Title: TTL Output Card

Project: Digital_Output_Card_V1_1.PrjPcb

Title: TTL IO Interface for External I/O

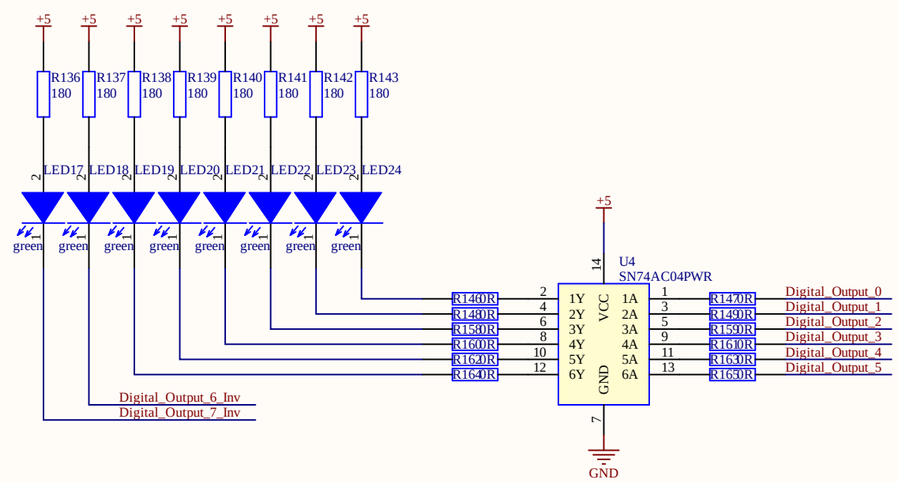
75ALS194EN term is inverted. I have corrected the schematic. and hand corrected the board
